SERVICE SLANTS

ISSUED BY WURLITZER SERVICE DEPT., NORTH TONAWANDA, N. Y.

MODEL 1100

LINK AND CANCEL SOLENOID ASSEMBLY - PART NO. 50276

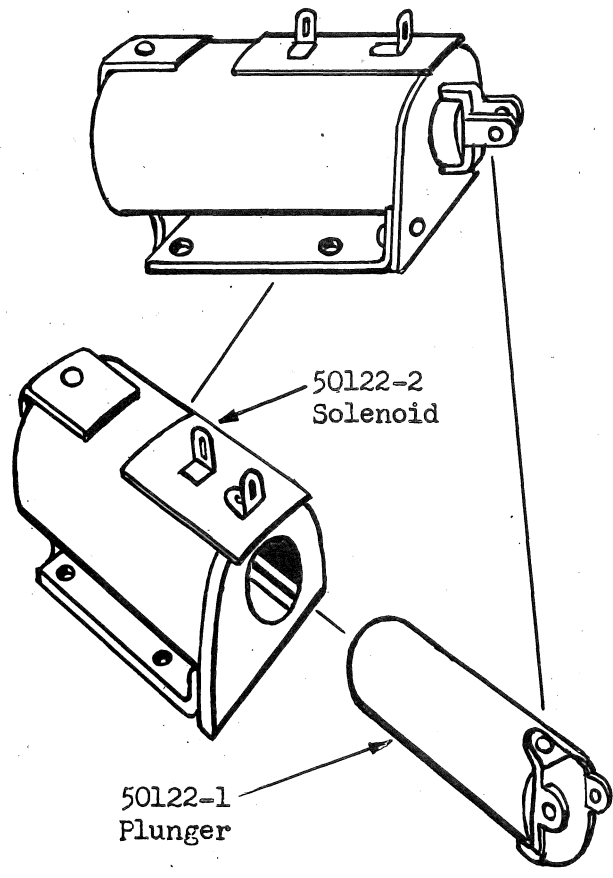
The specifications for the Model 1100 indicate two types of cancel solenoids, (#50276 and #49733), pictured on Page 6 in the Parts Section of the Service Manual. We wish to advise that all Model 1100's are equipped with 50276 and that 49733 was never used.

We receive an occasional order for a part of this assembly which is not pictured separately in the catalog. Therefore, we are assigning part numbers to the Solenoid Only, Plunger Only, Rivet, Spacer and Link. These items will be stocked individually.

You will note we have marked this Service Slant as "Page 6-A" and suggest it be inserted in the Parts Catalog to be convenient when referring to this Assembly.
